# **Final Environmental Statement**

related to the operation of  
**Catawba Nuclear Station,**  
**Units 1 and 2**

Docket Nos. 50-413 and 50-414

Duke Power Company, et al.

Figure 4.2 Station water use, Catawba Nuclear Station  
 Source: ER-OL Figure 3.3.1-1, Revision 2

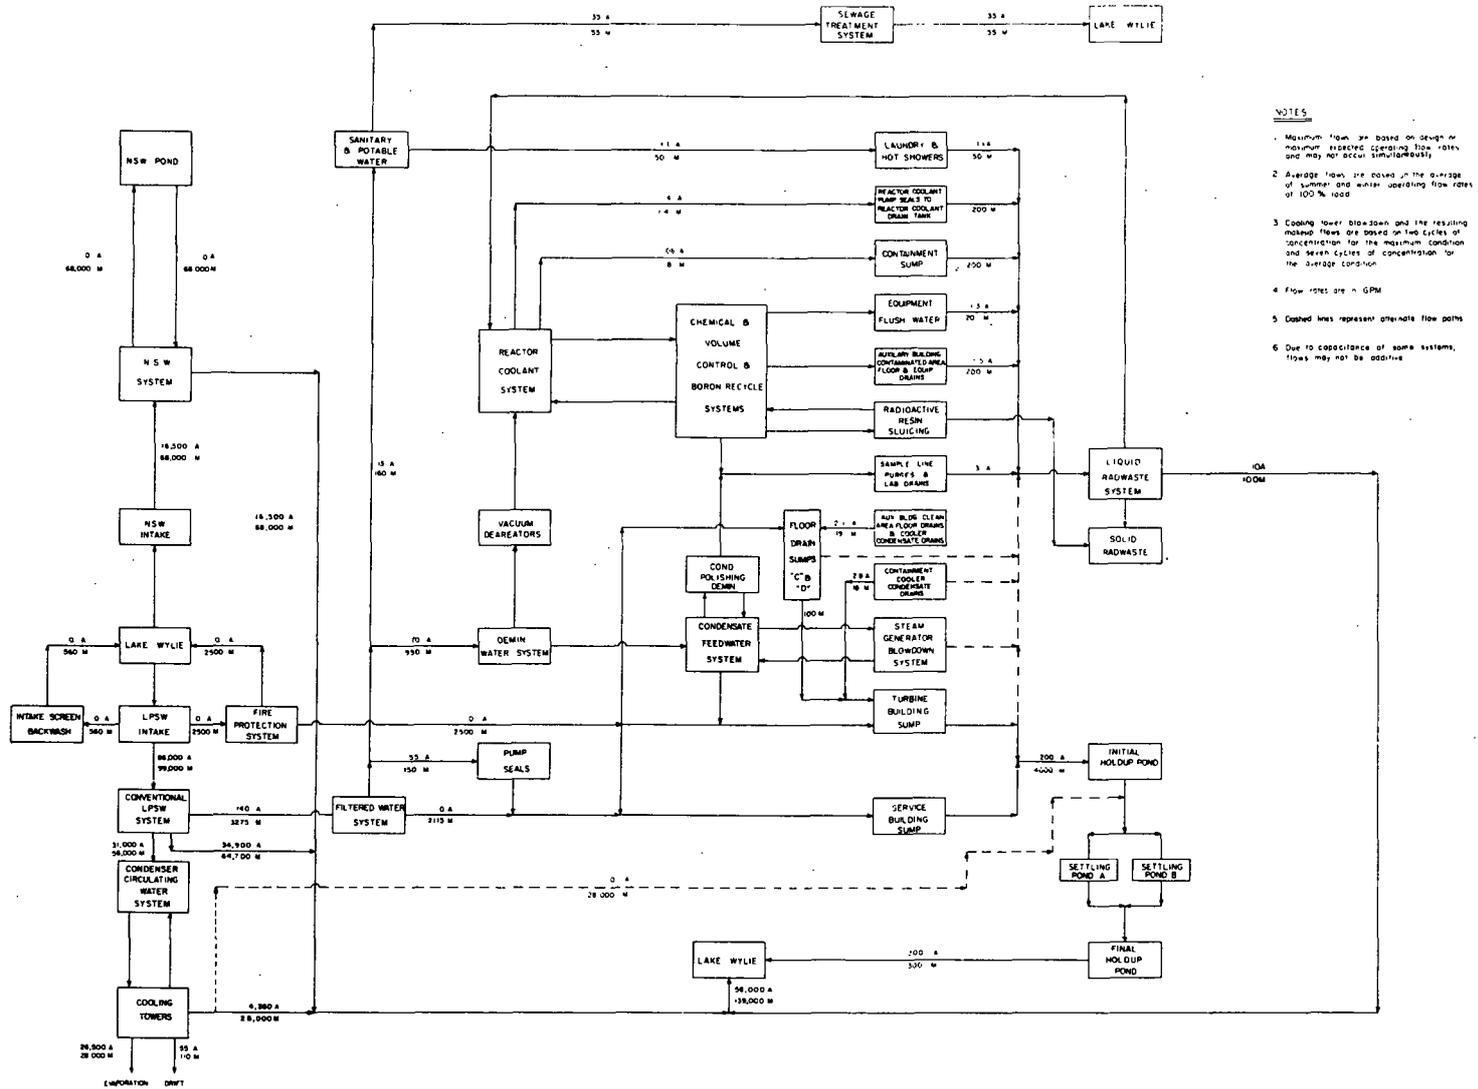
19  
cont The values of 6.4 m<sup>3</sup>/sec and 227 cfs do not agree with average and maximum values given in the EROL. After the appropriate conversion of 99,000 GPM, (EROL Figure 3.3.1-1) these values should be 6.2 m<sup>3</sup>/sec and 221 cfs, respectively.

Figure 4.3 Nonradiological release points  
Source: ER-OL Figure 2.1.1-5, Revision 3

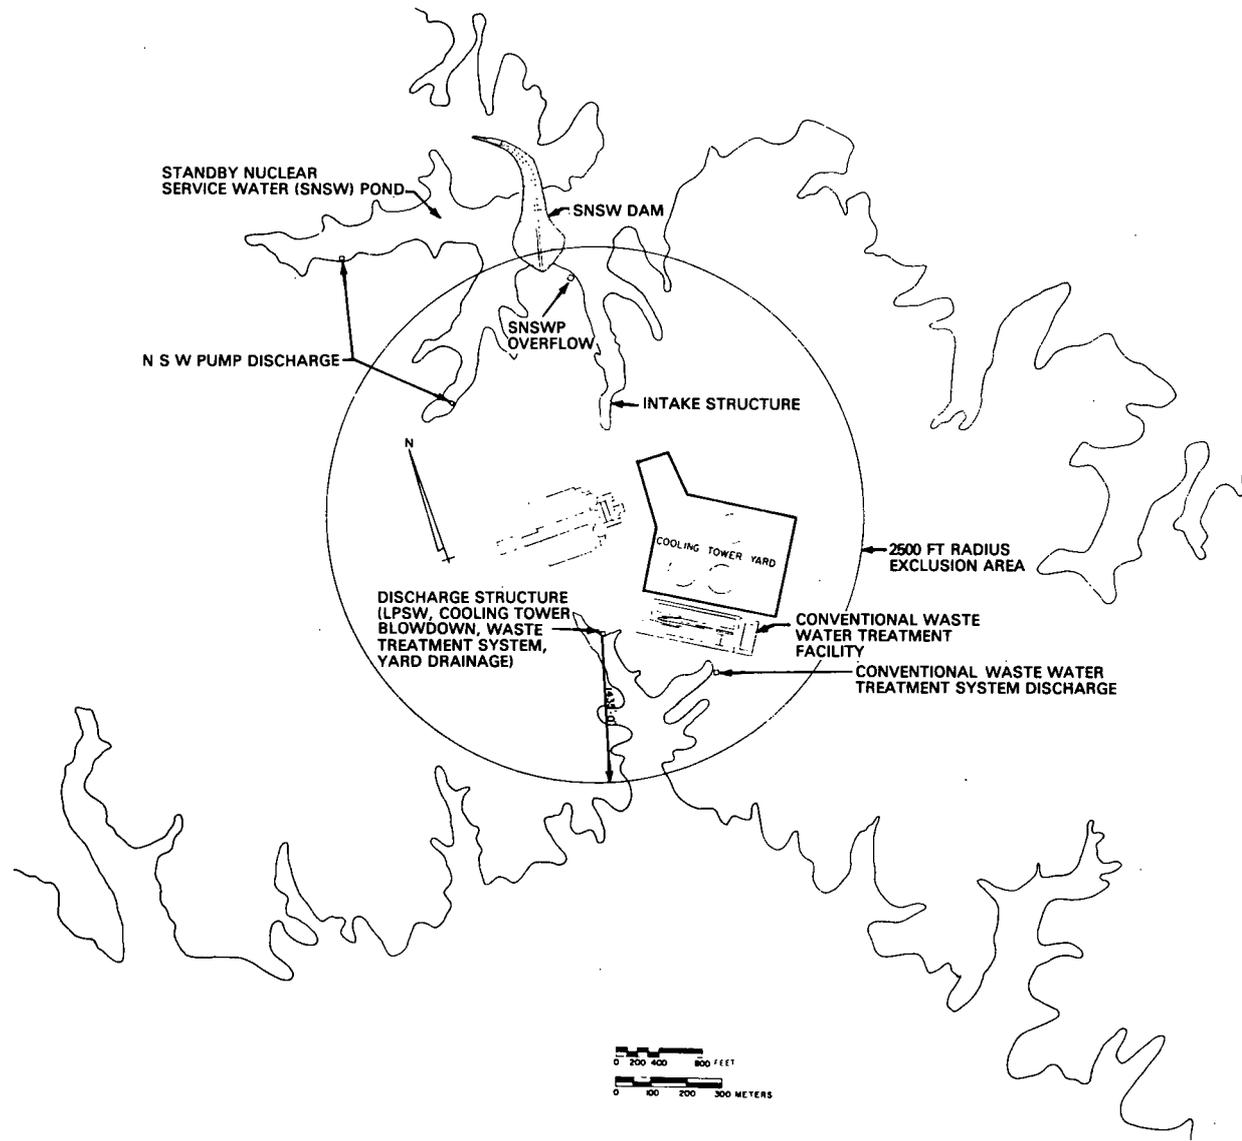
Figure 4.3 Nonradiological Release Points

As indicated below the figure title Figure 4.3 is taken from the applicant's ER-OL. The locations of the structures referred to by the various figure notations have been clarified on the figure. The clarifications of the routing of the various discharges indicated in the comment have been made in the FES text.

Figure 5.1 Potentially meaningful exposure pathways to individuals

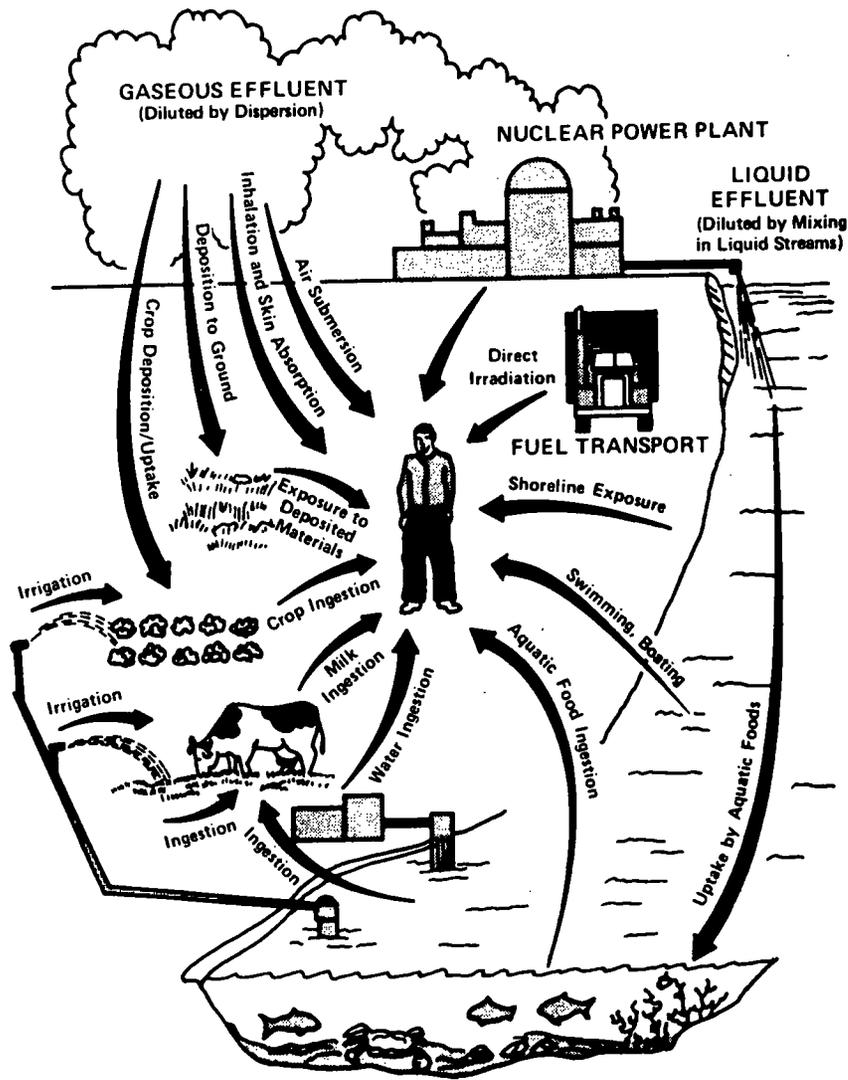
#1 { 3. Discussion in Section 5.9.4 on the environmental impact of postulated accidents is considered to be an adequate assessment of the radiation exposure pathways depicted in Figure 5.1 and the dose and health impacts of atmospheric releases. However, in Section 5.9.4.2(2), two additional possible pathways are mentioned. These are (1) radioactive fallout onto open bodies of water, and (2) the "China Syndrome" that creates the potential for release of radioactive materials into the hydrosphere through contact with ground water. A discussion of this latter pathway has been included in Section 5.9.4.5(5). It would be helpful in understanding the consequences of the former, if some discussion of that pathway could also be included in an appropriate section, possibly in Section 5.9.4.5(5).

2. The environmental pathways identified in Section 5.9.3, and shown schematically in Figure 5.1, cover all possible emission pathways that could impact on the population in the environs of the facility. The dose computational methodology and models (Appendix D and E) used in the estimation of radiation doses to individuals and populations within 80 km. of the plant have provided the means to make reasonable estimates of the doses resulting from normal operations and accident situations at the plant. Results of the calculations are shown in Appendix D, Tables D.6, D.7, D.8 and D.9 and confirm that the calculated doses meet the design objectives.

Figure 5.7 Probability distribution of mitigation measures cost (see Section 5.9.4.5(7) for a discussion of uncertainties in risk estimates)

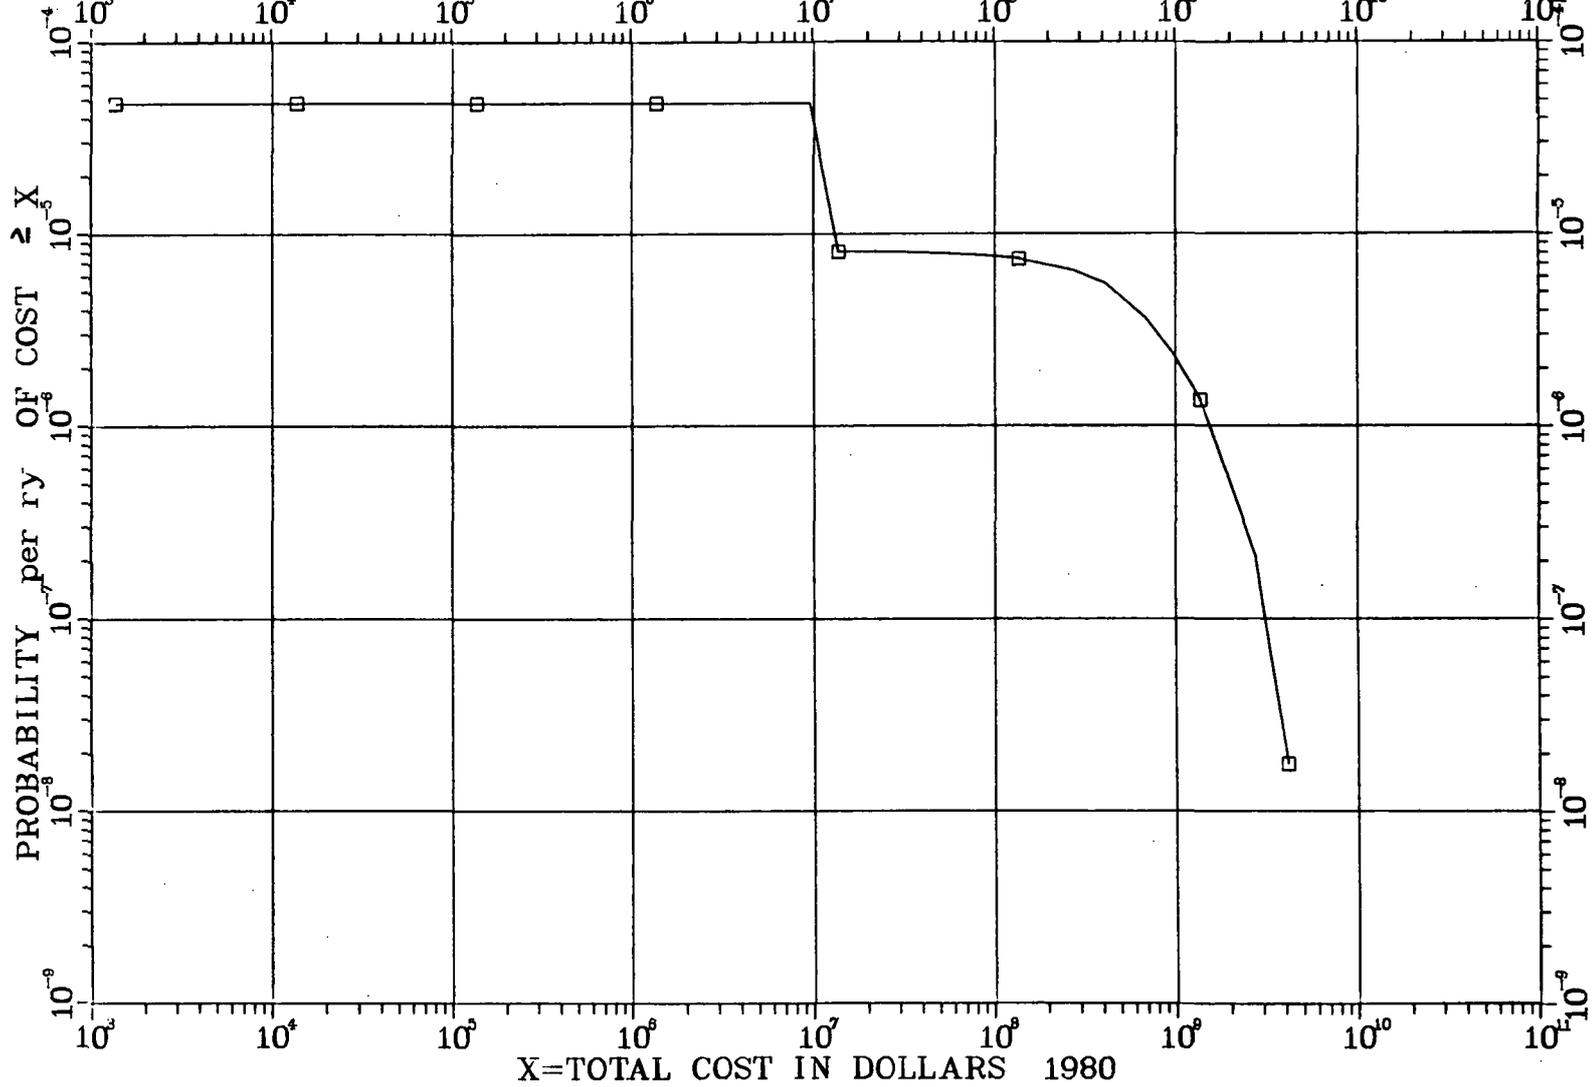
- # 18. The DES considers interdiction to reduce the radiological impact from severe accidents, p. 5-40. The costs of interdiction are considered in figure 5.7 and Table 5.11. However, an evaluation of the availability of facilities for relocation and the non-monetary impacts of the location are not considered. This topic was not addressed in the CP FES and is not adequately considered in the DES.
